PLANNING COMMISSION
DATE: 11/14/2016
AGENDA ITEM: 5A – PUBLIC HEARING
CASE # 2016-40

ITEM: Wildflower at Lake Elmo 2nd Addition Final Plat and Final PUD Plans
SUBMITTED BY: Stephen Wensman, Planning Director
REVIEWED BY: Emily Becker, City Planner
Jack Griffin, City Engineer

PLANNING COMMISSION
DATE: 10/10/2016
AGENDA ITEM: 4B – PUBLIC HEARING
CASE # 2016-40

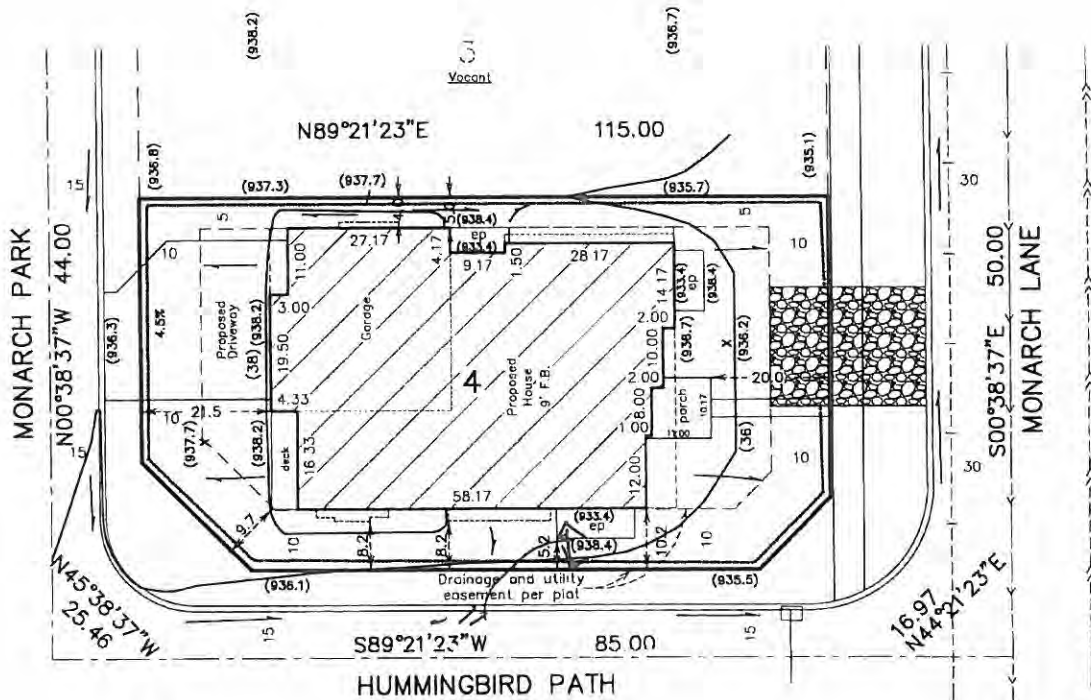
2. Street trees need to be at least 5 feet from back of curb. In areas where the boulevard does not allow this because of sidewalk or trail placement as noted on Sheet L1 please redesign to accommodate required trees.

9. Minimum size for ornamental trees is 2" Caliper per Table 6-1. Minimum Size Standards for Landscape Materials within the City's landscape requirements.

10. Please provide more diversity of all plantings – overstory trees, evergreen trees and ornamental trees. For example specify more than one type of evergreen on the entire project. Perhaps focusing on pollinator friendly choices would work nicely with the overall theme of the development. 211 Black Hills Spruce is not acceptable as the only evergreen specified,

52 PrairieFire Crab is too many of one type of Crab, try to limit the use of Honey Locust as it provides filtered light at best as a street tree, etc. as a few examples.

11. Please provide design sections for all berms / landscape screening suggested representing all typical planting arrangements with species specified and represented to scale at time of installation. When planting berms please consider planting side slopes verses simply planting the top as it is currently suggested. Plants are much happier when not placed on the highest, driest and windiest part of the berm.

Figure 1

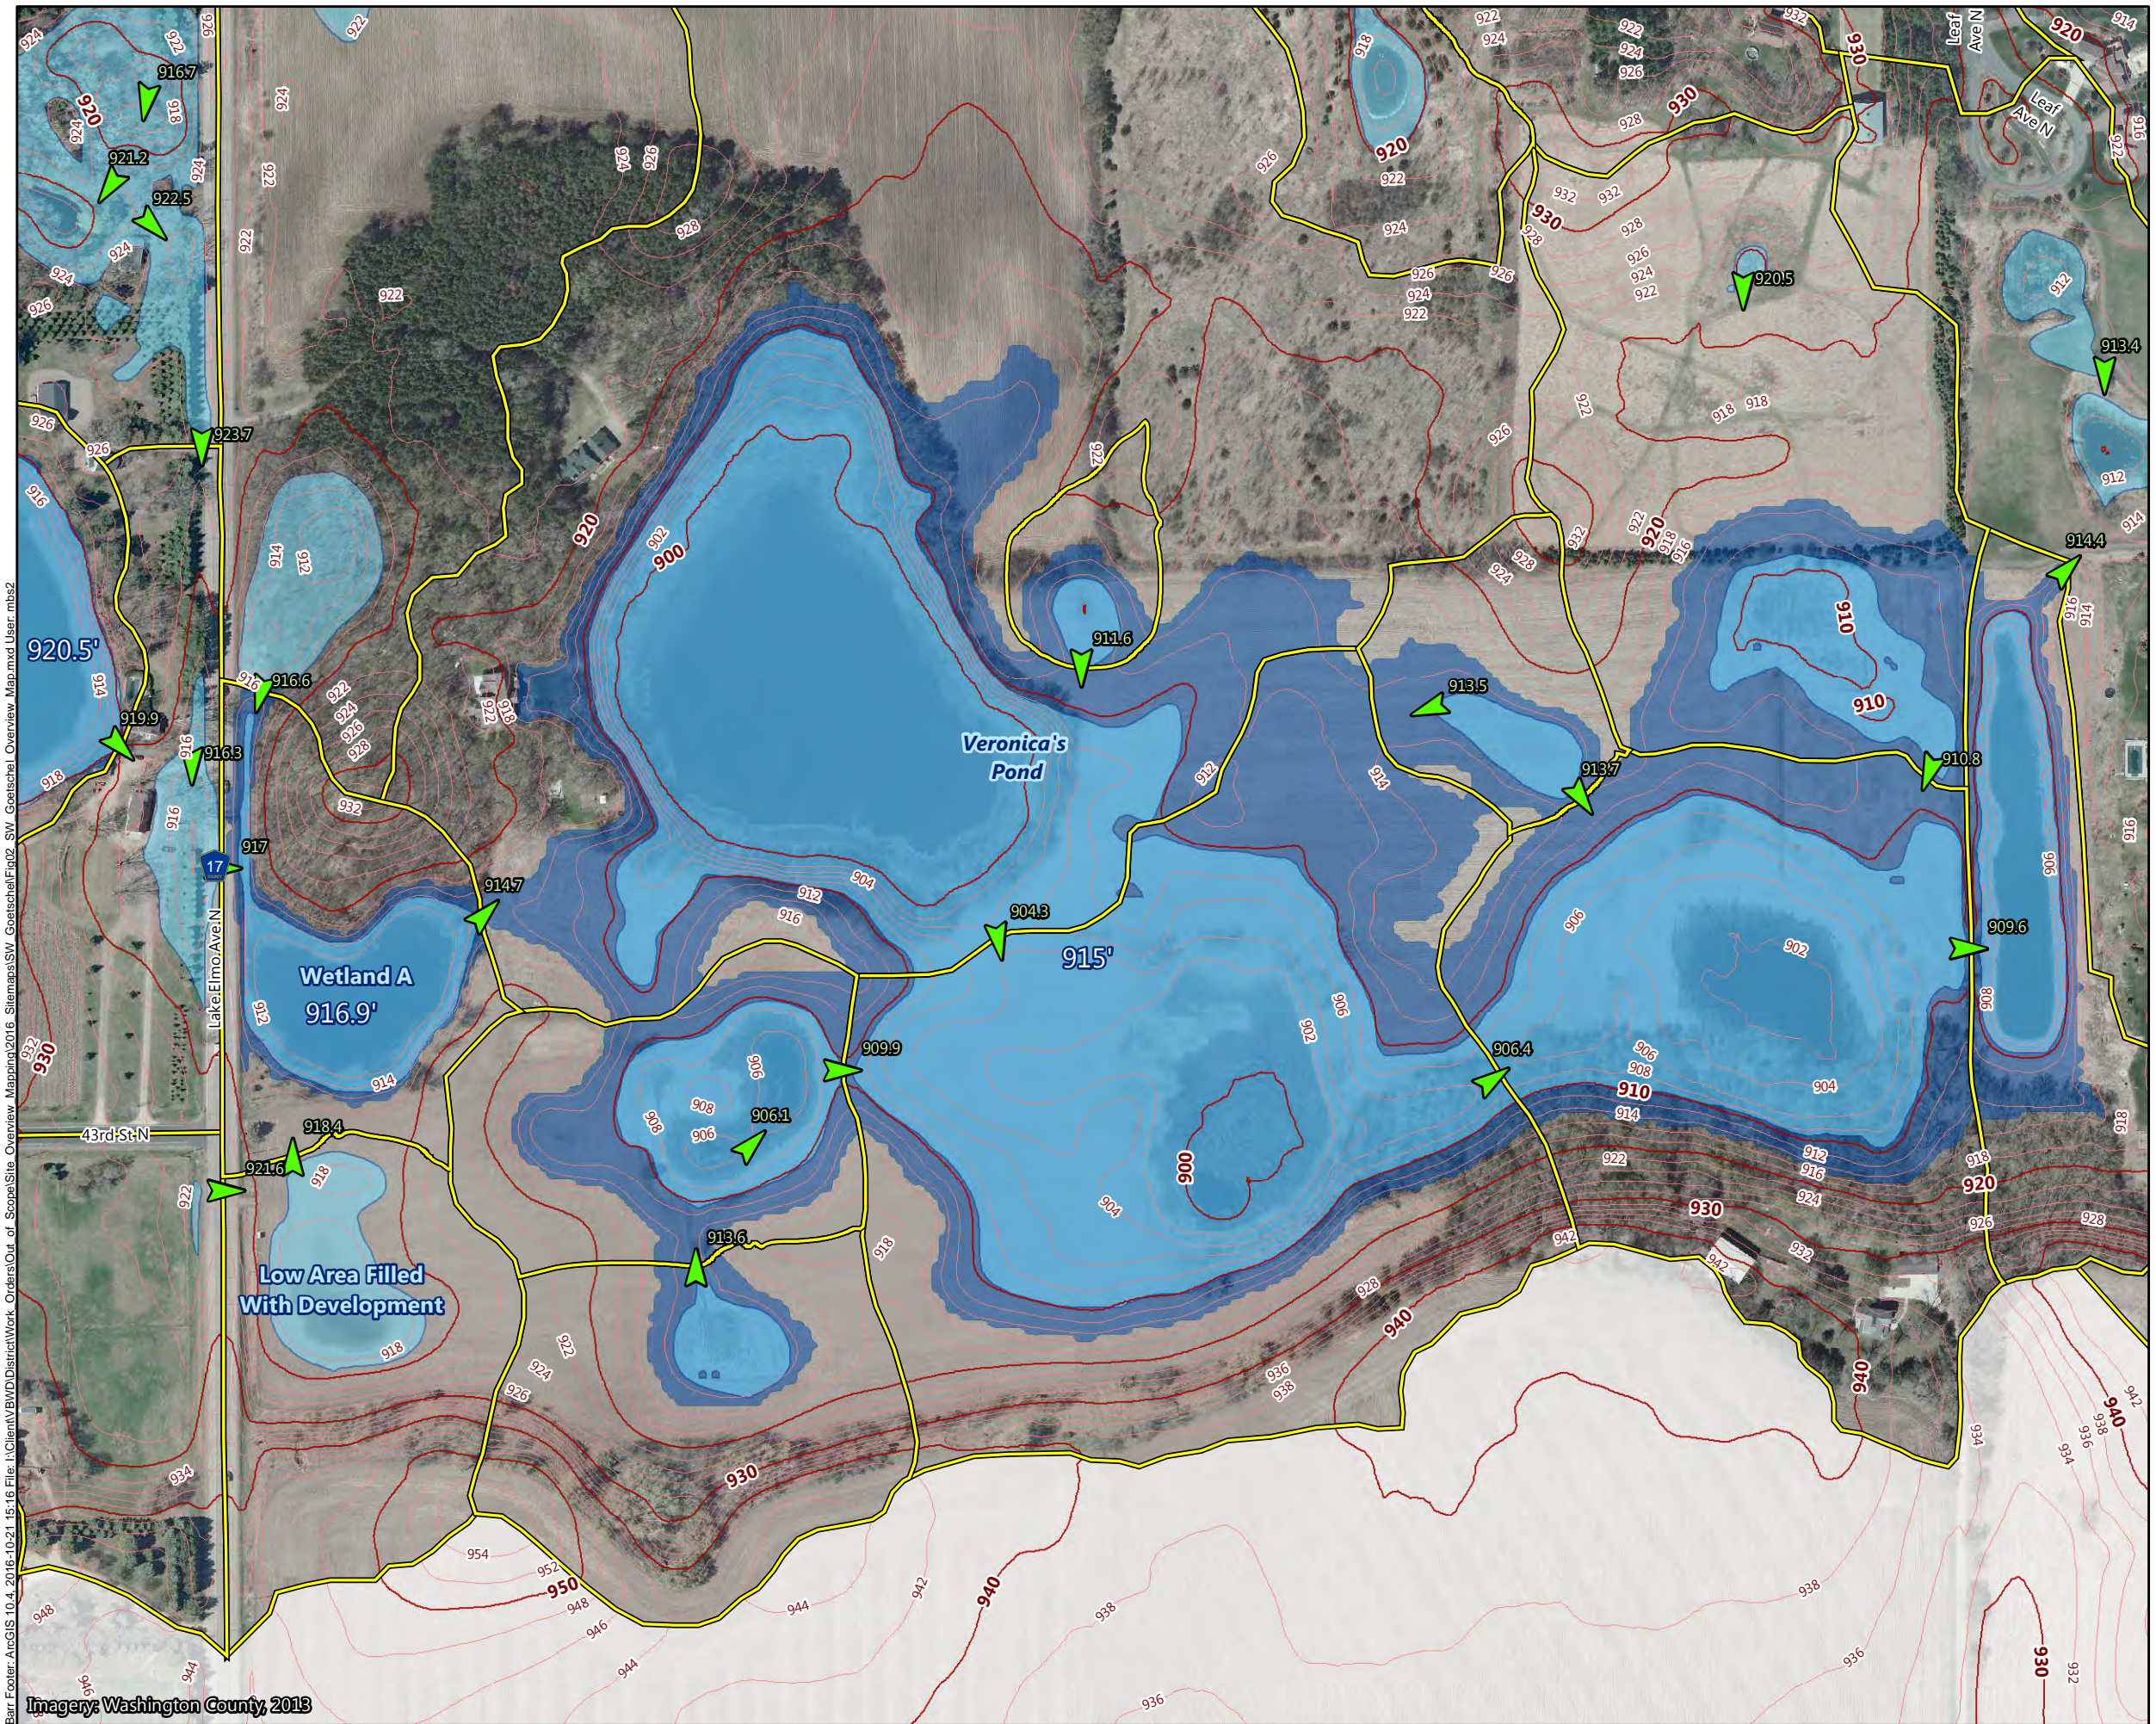
Areas south of the floodplain are currently under construction. Figure 1 shows the developments in relation to the floodplain. Village Preserve and Arbor Glen Senior Living are on the west side and Wildflower at Lake Elmo is on the east side; a future cul-de-sac extends to the west, separating the floodplain from Village Preserve.

Within the Wildflower at Lake Elmo site (see Figure 1), the developer filled a low area south of Wetland A (see Figure 2). That area now drains to an infiltration basin (Infiltration Basin 300) that overflows to Wetland G (see Figure 3). This change, combined with the Village Preserve drainage change, reduced the drainage area to Wetland A by 5.1 acres. Under pre-developed conditions, runoff from the south would fill that low area; if it were to overflow, it would overflow to Wetland A.

Figure 2

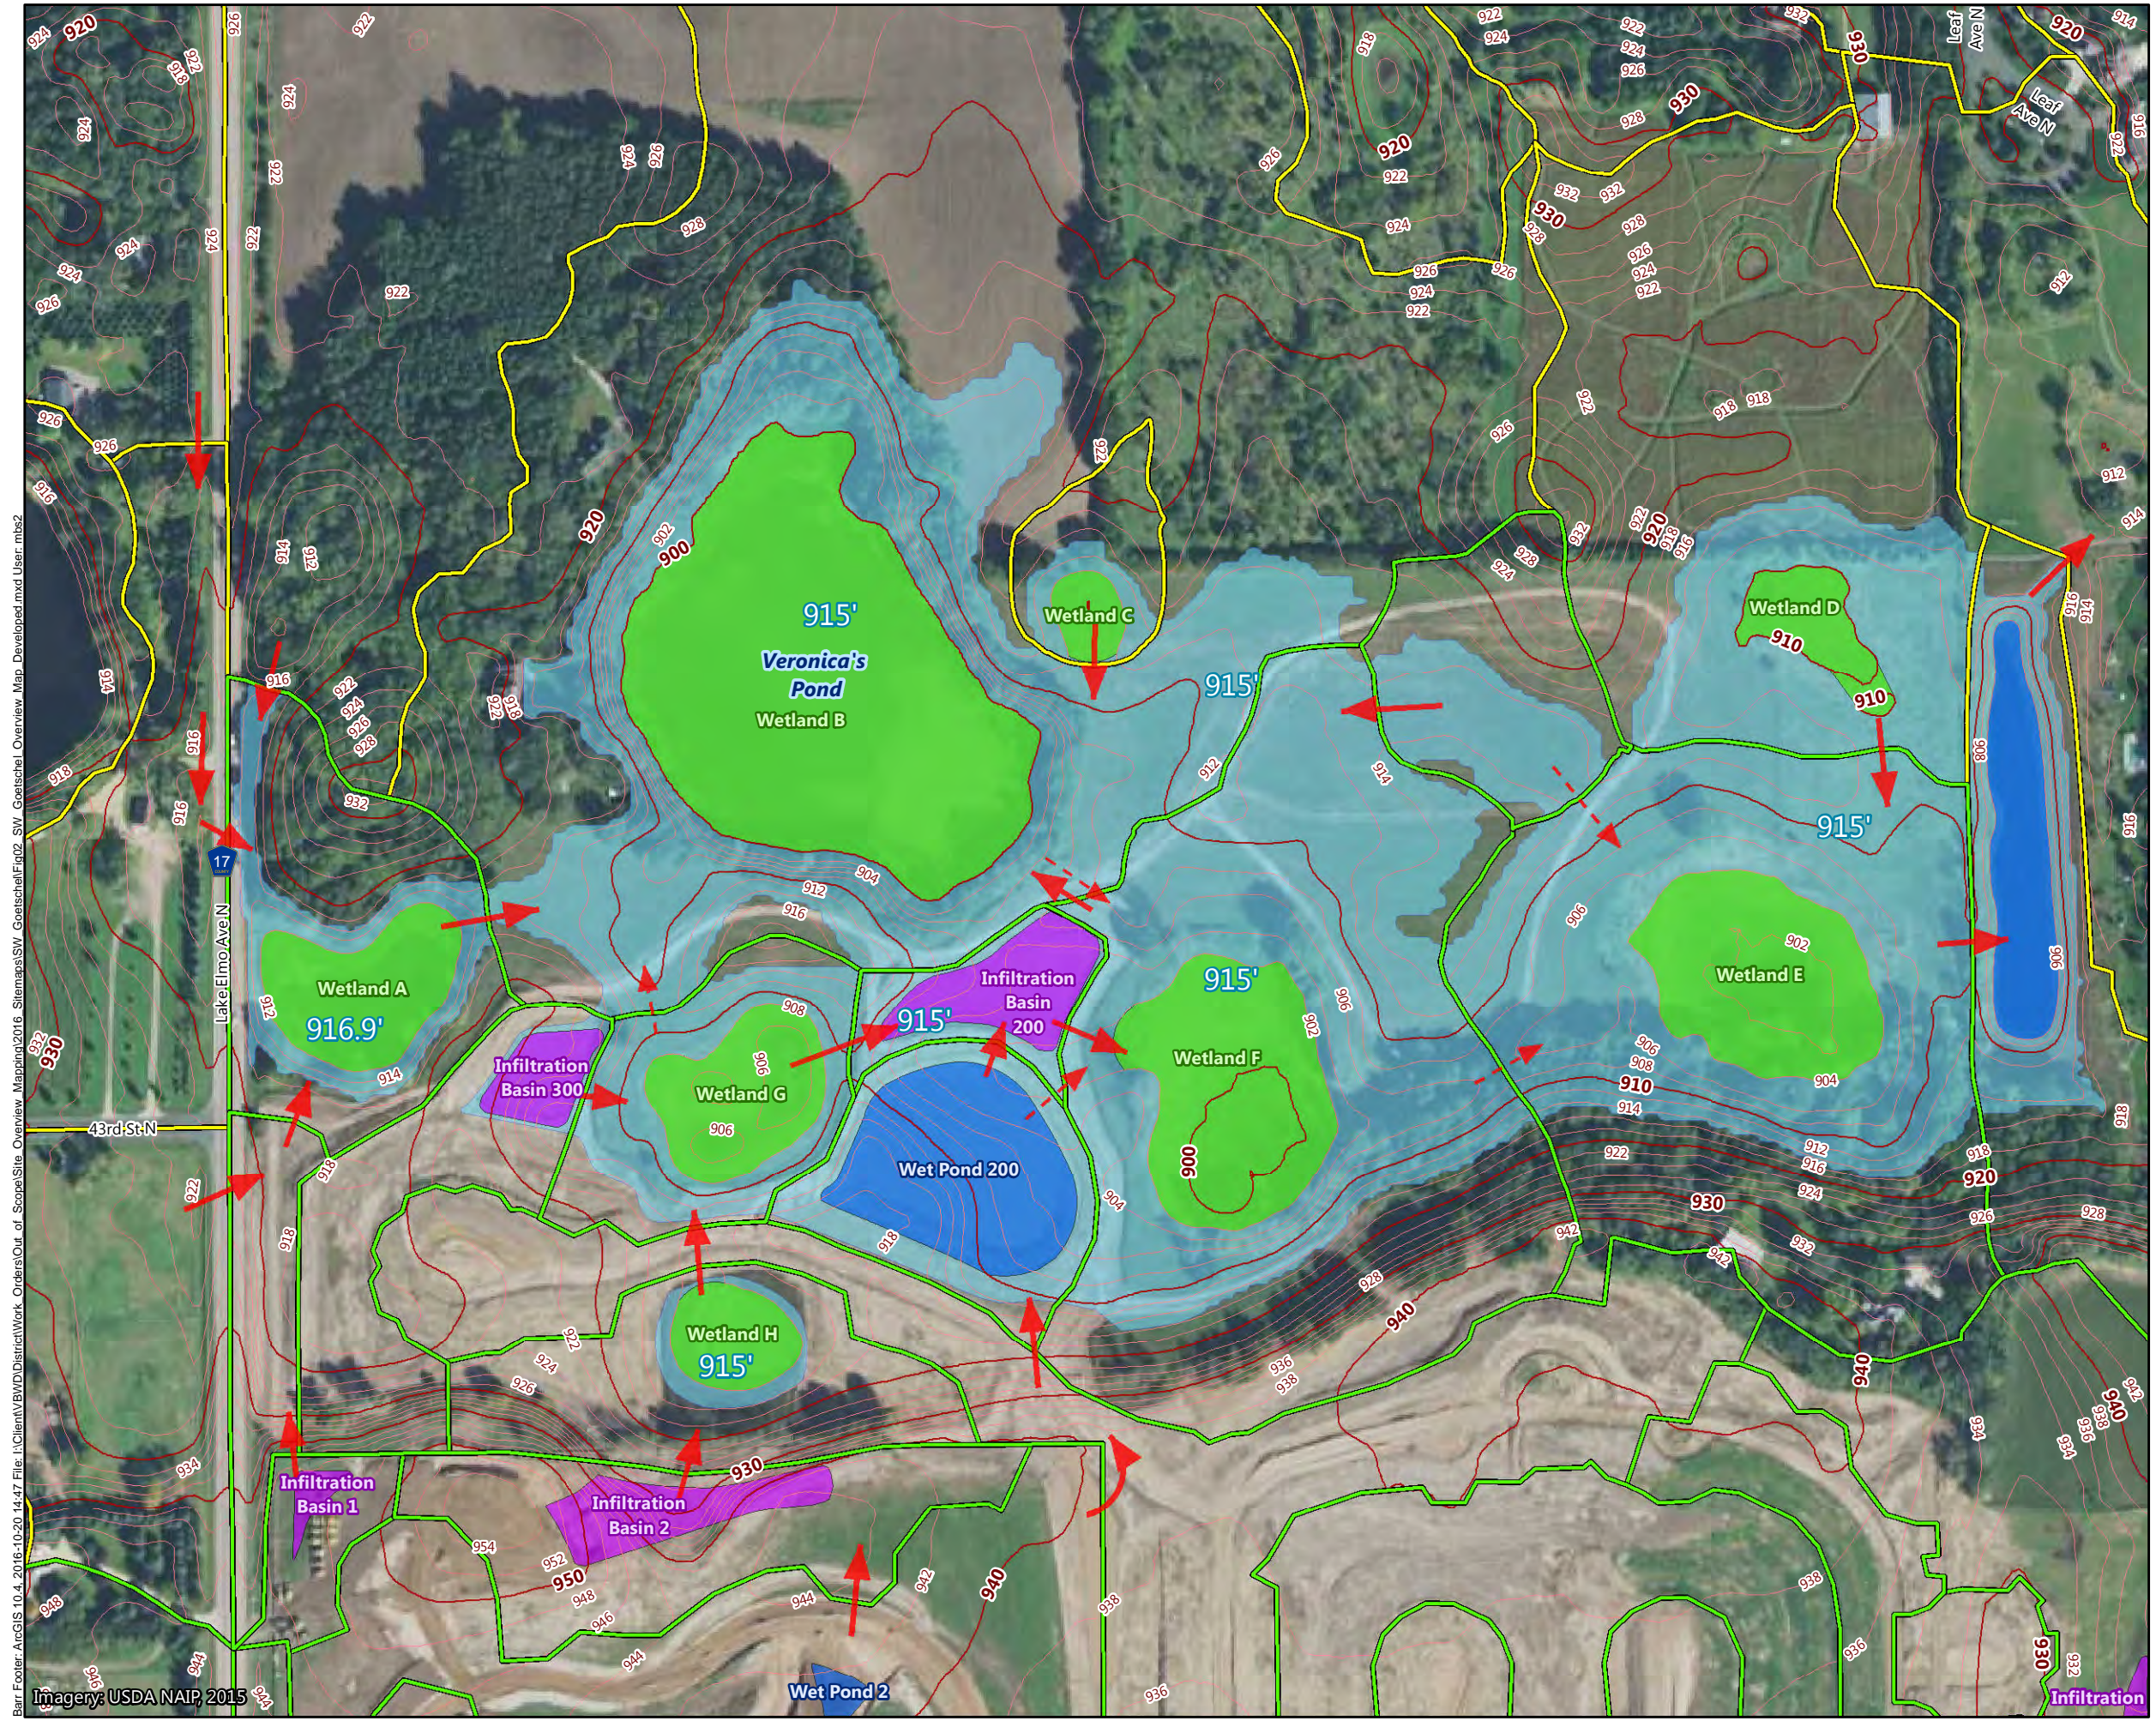
Figure 2 shows the pre-development drainage patterns, overflow elevations of lowlands, and the 1%-probability flood level for the area. Figure 3 shows the developed conditions drainage patterns and 1%-probability flood level for the area.
